**REVISION
TO
VOLUME IV OF IV REPLACEMENT
AMENDMENT TO FINAL CLOSURE PLAN
LOPEZ CANYON SANITARY LANDFILL
LAKEVIEW TERRACE, CALIFORNIA**

**BOARD'S COMMENTS ON REPLACEMENT VOLUME IV OF THE FINAL
CLOSURE PLAN FOR LOPEZ CANYON SANITARY LANDFILL**

SUMMARY TABLE OF REVISIONS TO VOLUME IV OF IV REPLACEMENT AMENDMENT TO FINAL CLOSURE PLAN

Subject: Adequacy of the Replacement Volume IV of the Final Closure Plan
for Lopez Canyon Sanitary Landfill, City of Los Angeles, Facility
No. 19-AA-0820

FIGURE NO. 2-4

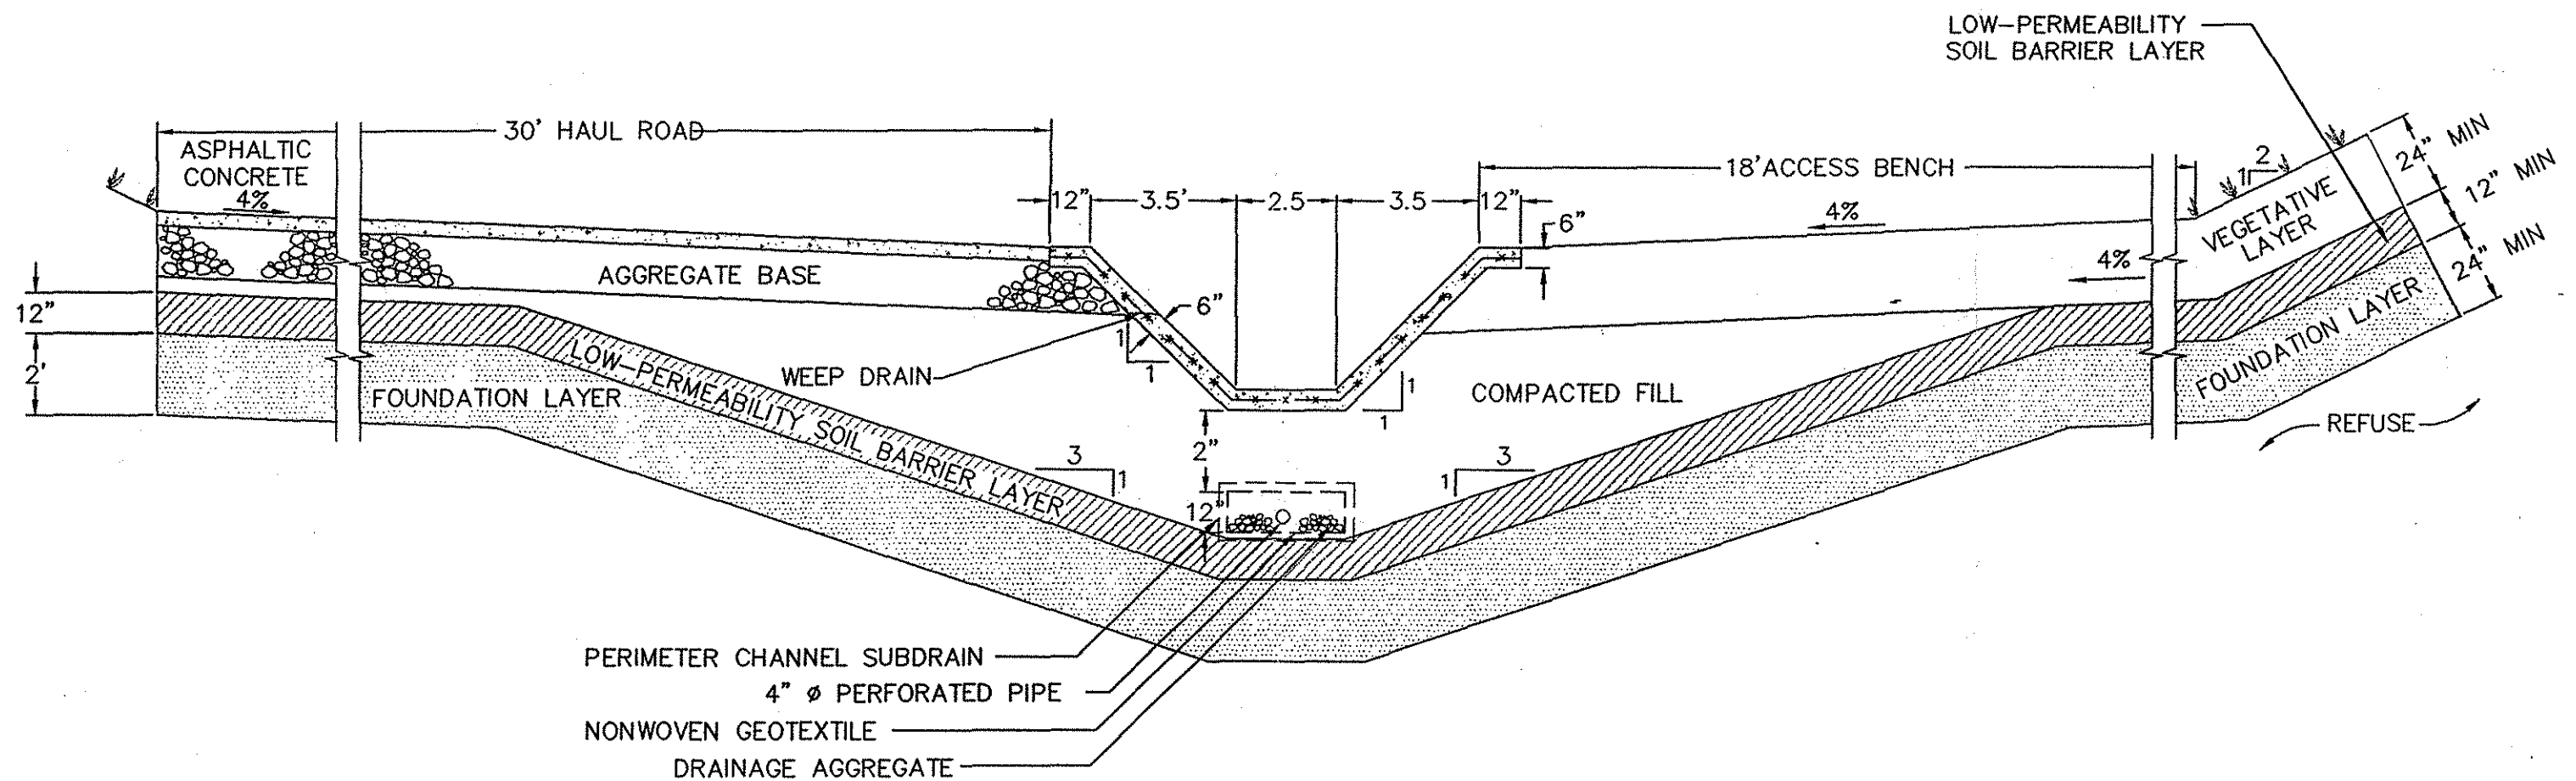
- e. The plan must provide design drawings for portions of the access road which is to be constructed over disposal areas (over final cover). Please include culvert details and final cover protection features.*

- (b) GeoSyntec has provided an analysis of the VFPE geomembrane to be used on the deck and benches of Area C. See Attachment F. This is to be included under Appendix III of Appendix H of the final closure plan. Section 3.2 of Appendix H has been revised to reflect this reference.
- (c) Drawings showing the extent of the synthetic membrane and corresponding key points in Area C are included in the Figures Section, Figure 2-1(a) through 2-1(e).
- (d) Appendix I, "Revised Construction Quality Assurance Plan," of the closure plan has been revised to include an appendix that provides supporting documentation used to establish the minimum design yield point. See attachment G.
- (e) Design drawings for the haul road which is to be reconstructed over refuse to the north of area AB+ have been included in the Figures Section, Figures 2-4 and 2-4(a) of the closure plan. See attachment E.

TYPICAL
"DESIGN YIELD
POINT",
TANGENT AT
290 psi2.5 5.0 7.5 10.0 12.5 15.0 17.5 20.0 22.5
DISPLACEMENT (in.)

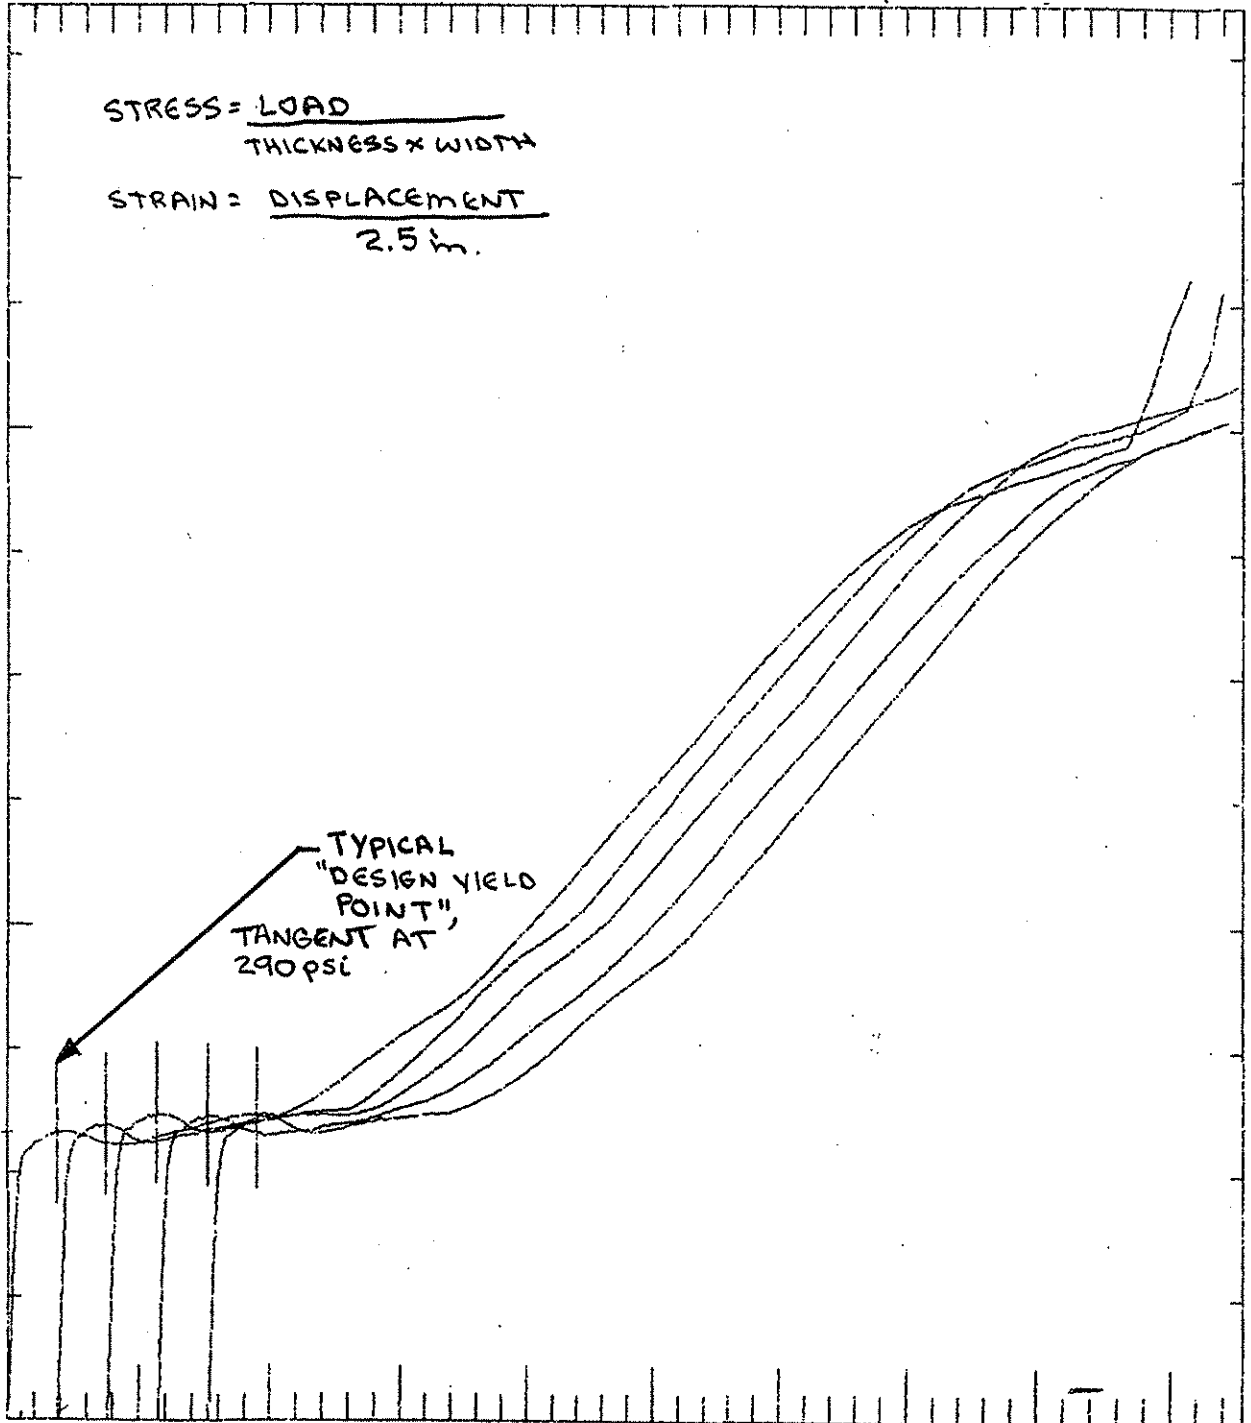
- d. The plan must provide supporting documentation used to establish the minimum design yield point and its interpretation as "the point on the stress-strain curve at which the tangent modulus first becomes 290 psi."*

ATTACHMENT I

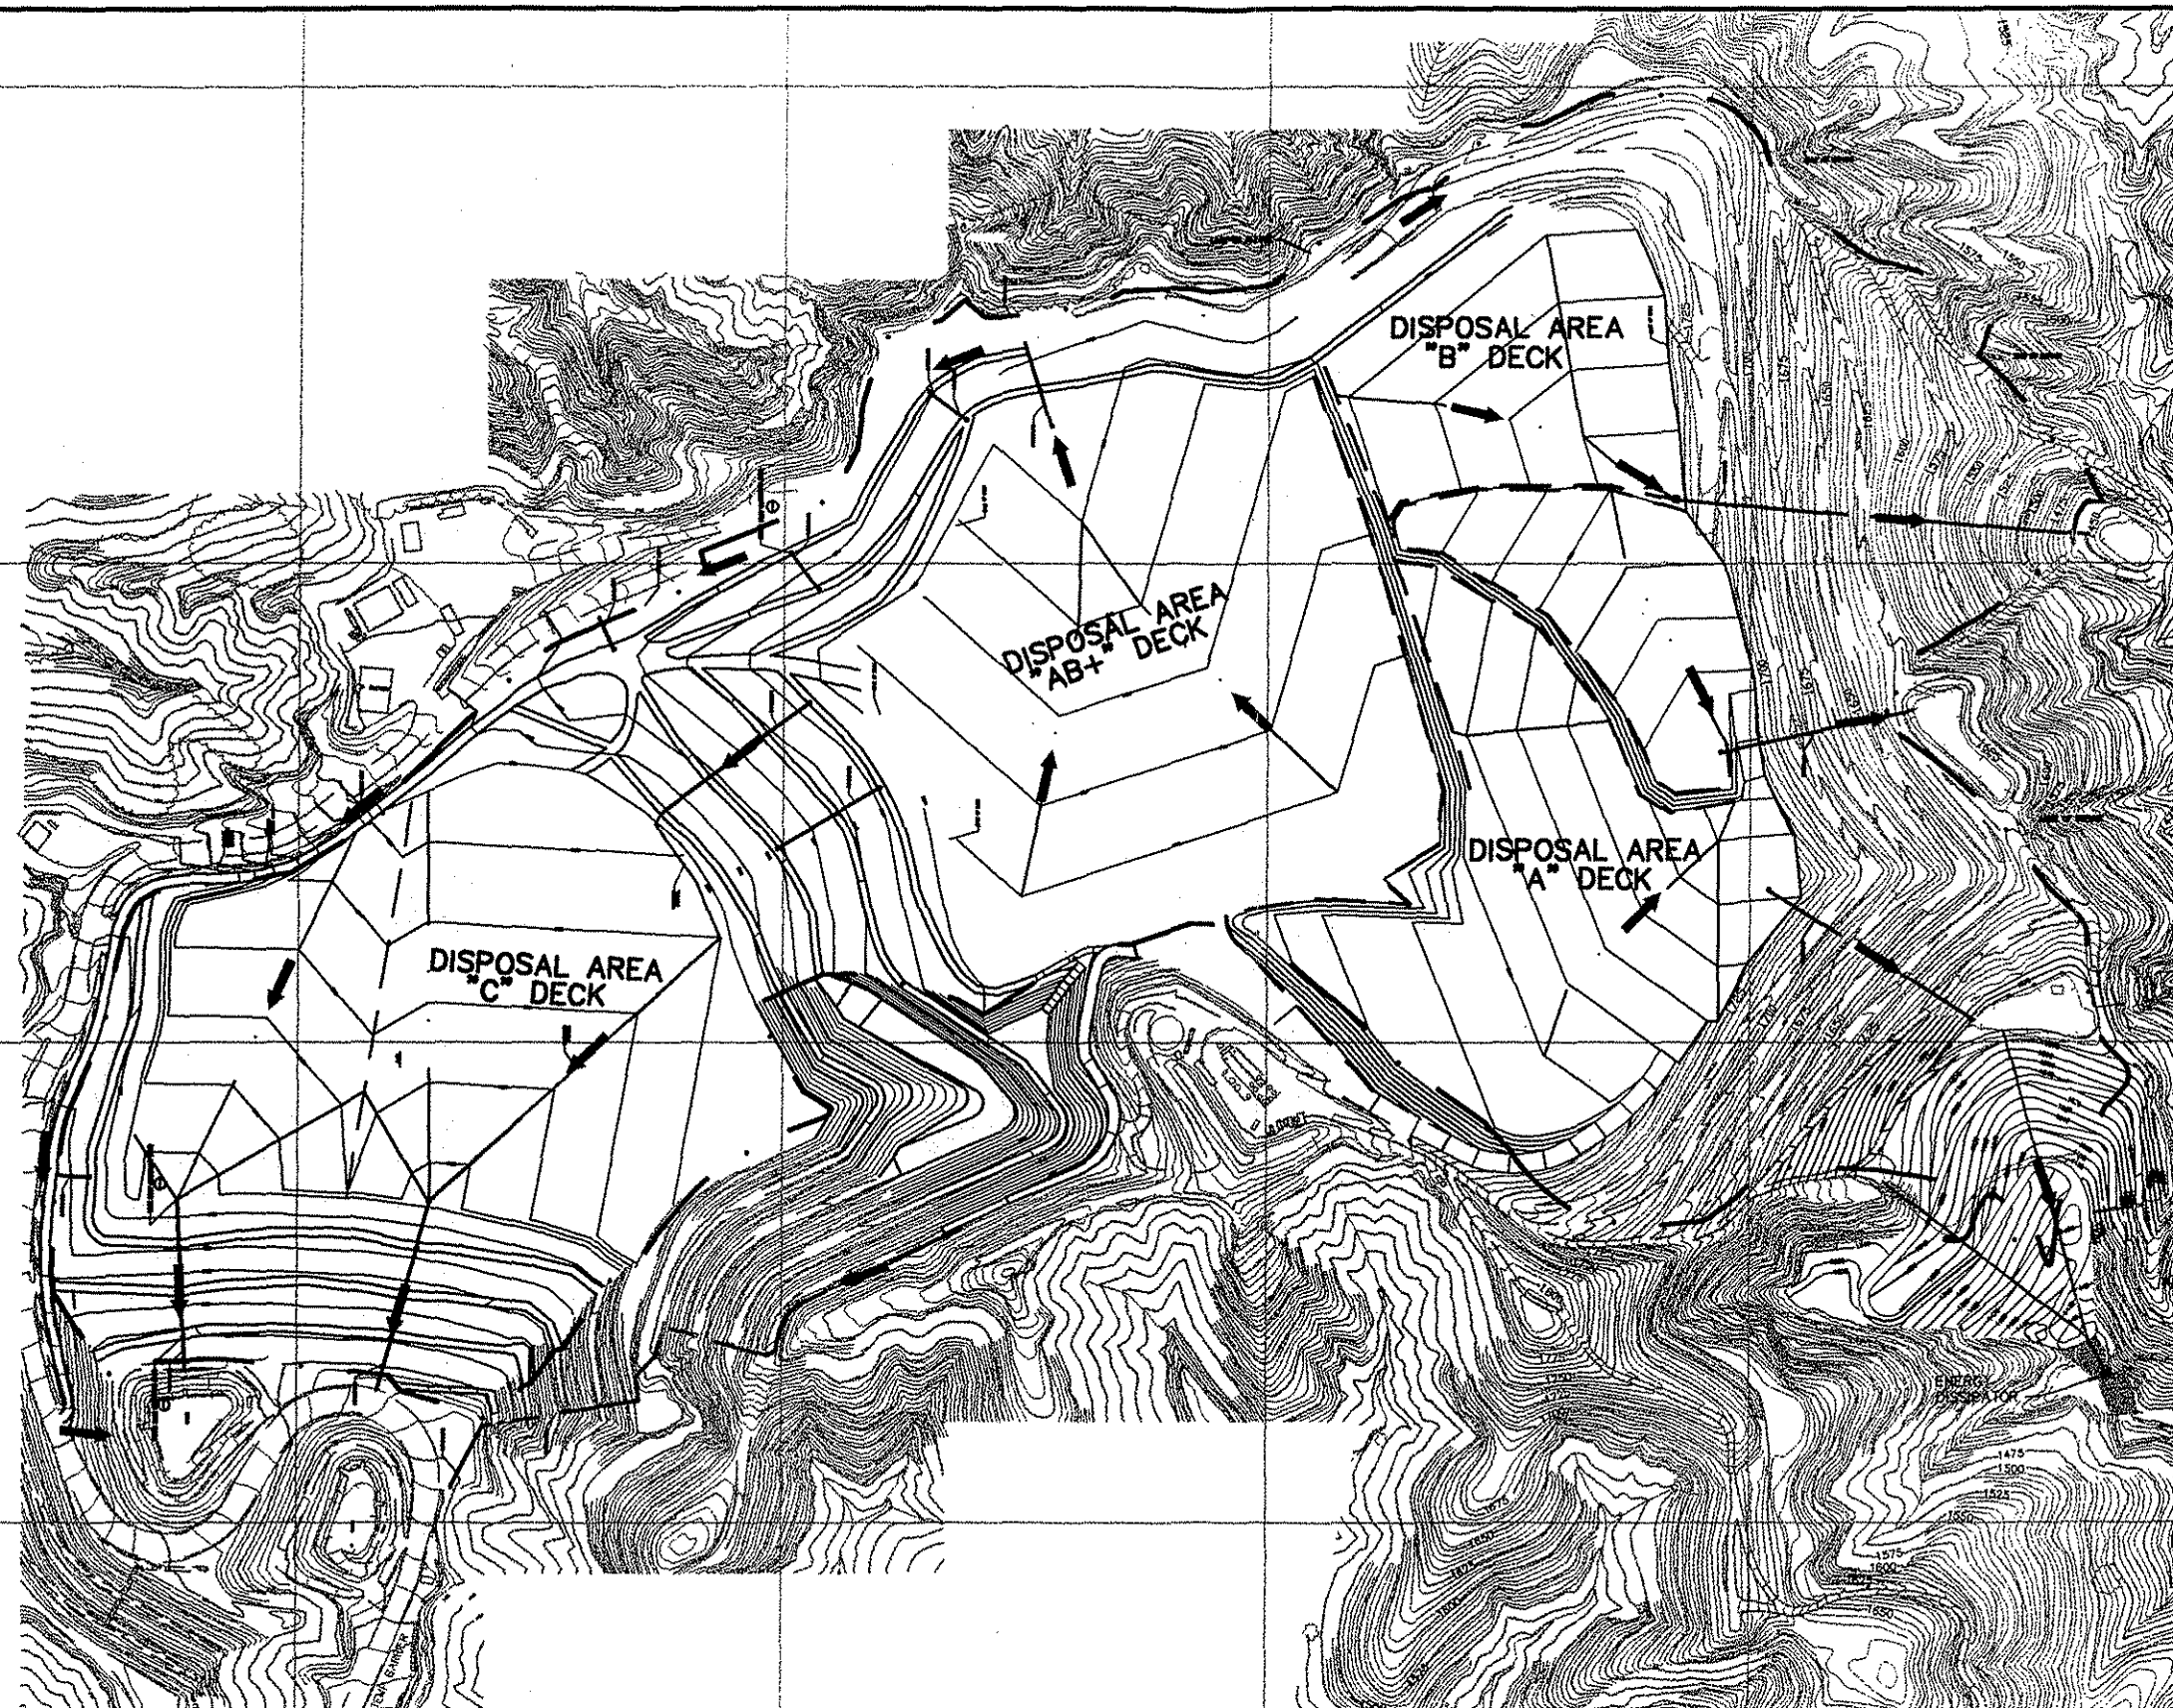
The plan must include a more detailed drawing showing the design of benches on the northern face of the AB+ disposal area slopes. Specifically, the interface between the eastern edges of the benches and the sheet flow area should be shown in detail.

The drawing depicting the drainage plan should include drainage patterns for the entire landfill in accordance with the design described in the revised plan.

Drawing No. 1 submitted with Volume IV of IV Replacement Amendment to the Final Closure Plan has been revised. See attachment I.

Figure No. 3-1 and Drawing No.1 submitted with Volume IV of IV Replacement Amendment to the Final Closure Plan have been revised. See attachment I.
